UNITED STATES PATENT AND TRADEMARK OFFICE

APPLICATION NO.	FILING DATE	FIRST NAMED INVENTOR	ATTORNEY DOCKET NO.	CONFIRMATION NO.
10/651,115	08/28/2003	Keith D. Mease	TN285	7863

Office Action Summary	Application No. 10/651,115	Applicant(s) MEASE ET AL.	
	Examiner Zachary M. Pape	Art Unit 2835

DETAILED ACTION

FIG. 1

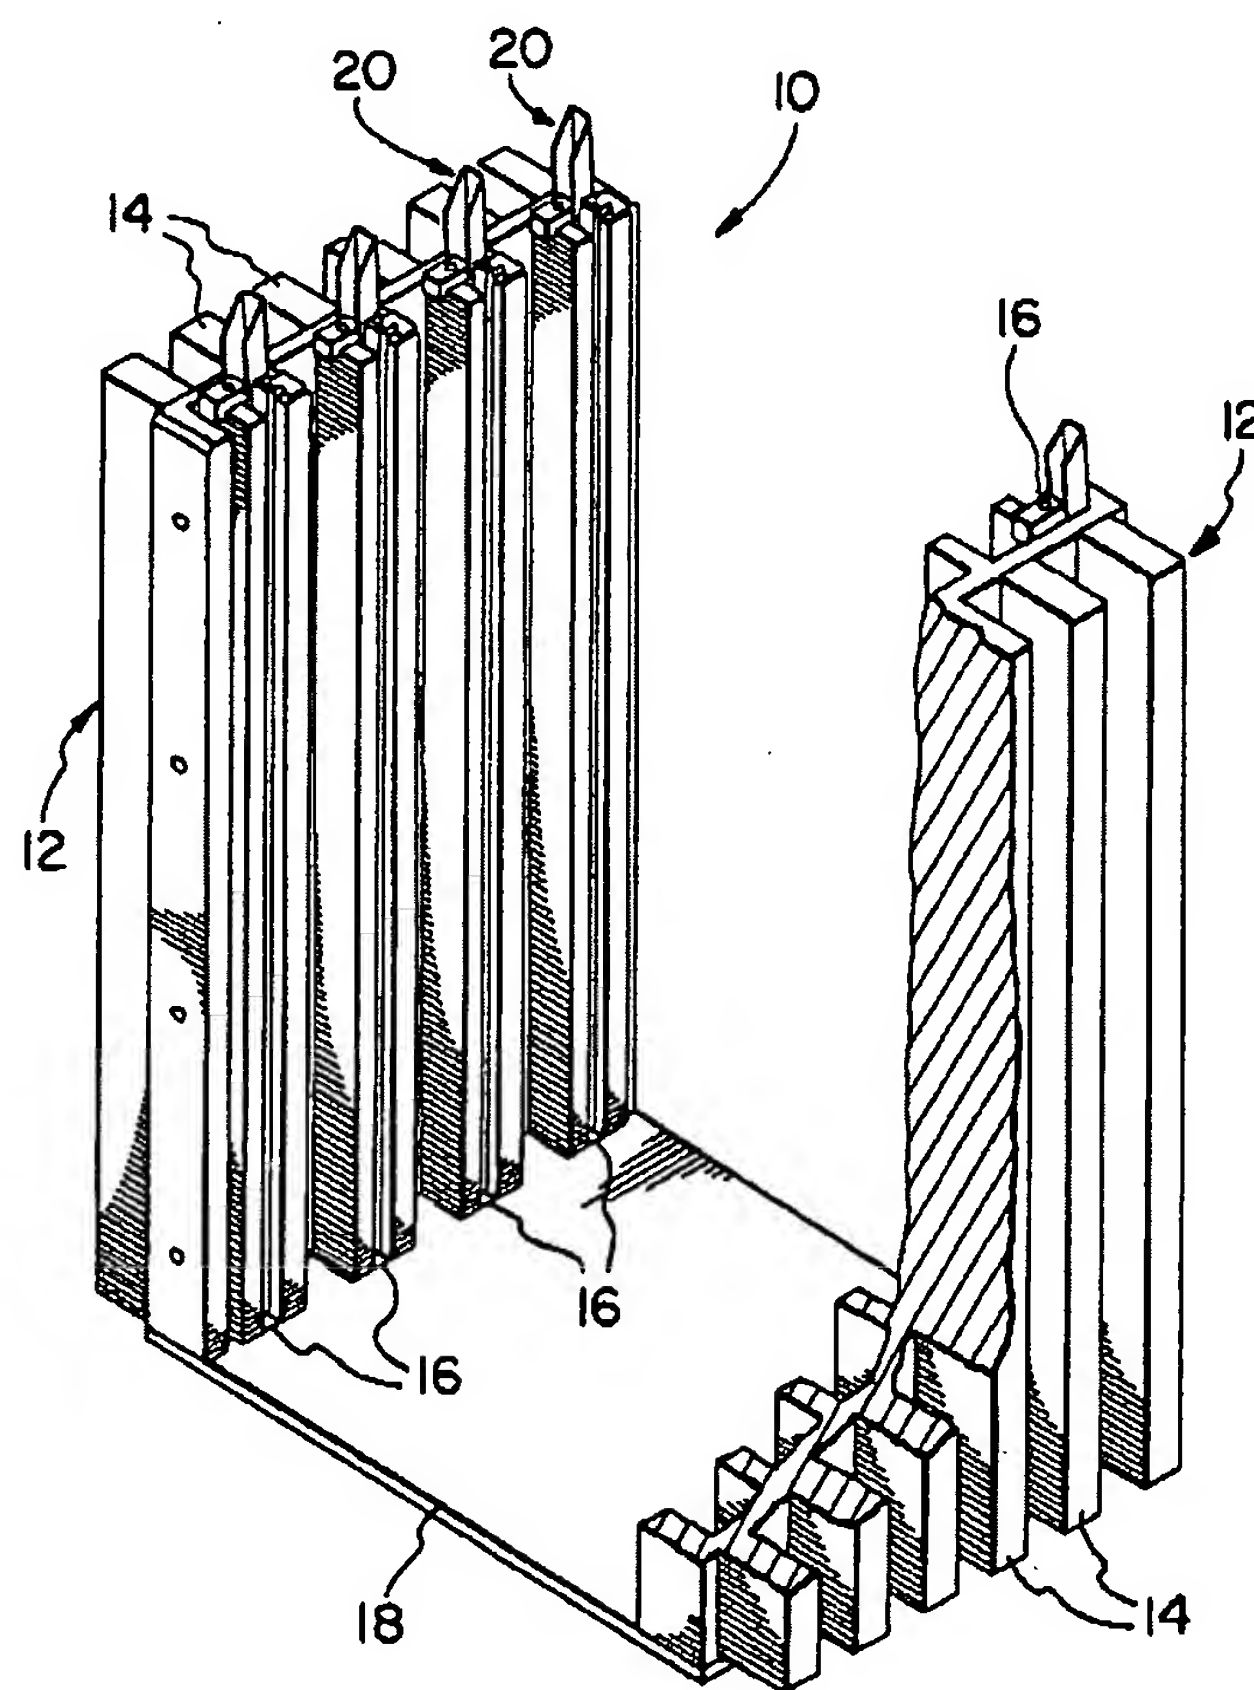
With respect to claim 1, Hughes et al. teaches a heat sink (10) configured to support an edge (82) of a circuit card (80), said heat sink comprising: a thermally conductive base (See present office action Fig 1 below); a plurality of thermally conductive heat dissipating fins (See POA Fig 1 below) extending perpendicularly from

said base; and one or more recesses (16) at least partially defined by adjacent parallel faces of said fins (See Hughes et al. Fig 2) the recesses having a depth smaller than the height of said fins (See Fig 2), said one or more recesses being configured to support the edge of the circuit card (Column 3, Lines 55-57).

With respect to claim 5, Hughes et al. further teaches a face disposed opposite said fins (See POA Fig 1 above), said base being configured to be mounted with said face abutting a heat-generating component (See POA Fig 1 above). [The Examiner additionally notes that, it has been held that the recitation that an element is "configured to" perform a function is not a positive limitation but only requires the ability to so perform and is therefore given little patentable weight. *In re Hutchison*, 69 USPQ 138.]

With respect to claim 9, Hughes et al. further teaches that the fins (See POA Fig 1 above) are oriented substantially parallel to one another (See Hughes Figs 1 and 2).

Fig 2

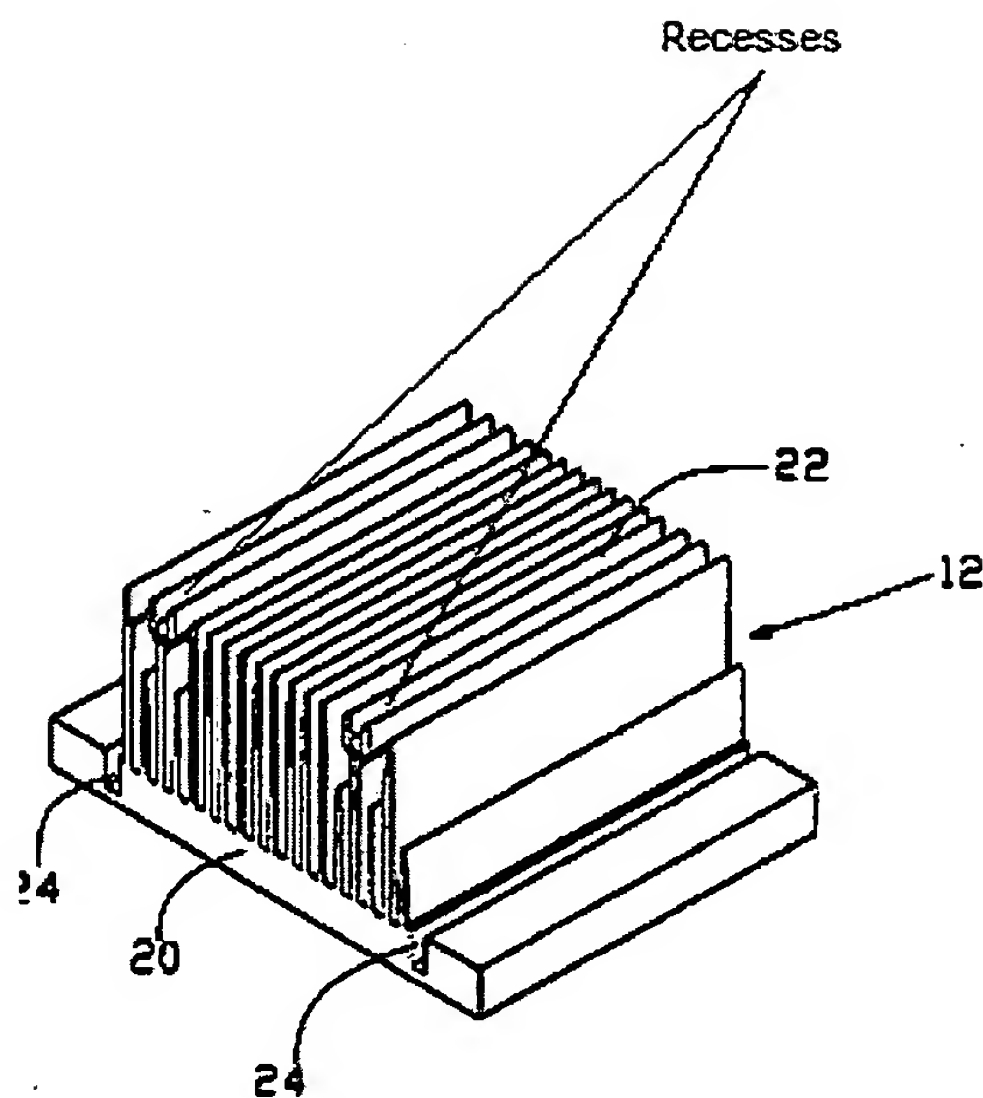
With respect to claim 1, Lo teaches a heat sink (10) configured to support an edge (74) of a circuit card (70), said heat sink comprising: a thermally conductive base (Generally 20); a plurality of thermally conductive heat dissipating fins (22) extending perpendicularly from said base; and one or more recesses (See Present office action Fig 1 below) at least partially defined by adjacent parallel faces of said fins (See Fig 1 below) the recesses having a depth smaller than the height of said fins, said one or more recesses being configured to support the edge of the circuit card.

With respect to claim 7, Lo further teaches that the recess is defined by a plurality of said fins (As illustrated in Fig 2 above).

computer system a heat sink (12) having a recess (See POA Fig 2 above) configured to receive an edge of a circuit card such that the recess orients the circuit card to enable mating the circuit card with a connector, the recess at least partially defined by at least one of a plurality of thermally conductive heat dissipating fins (22), the recess having a depth smaller than the height of said fins (See Lo Fig 1). Lo is silent as to a circuit card, and position the edge of the circuit card in the recess. Hughes et al. teaches the conventionality of a circuit card edge (82) which is positioned within a recess (16) of a heat sink (12). It would have been obvious to one of ordinary skill in the art at the time the invention was made to mount a circuit board in a heat sink recess as taught by Hughes with the teachings of Lo to make economic and efficient use of a heat sink (Column 2, Lines 3-7).
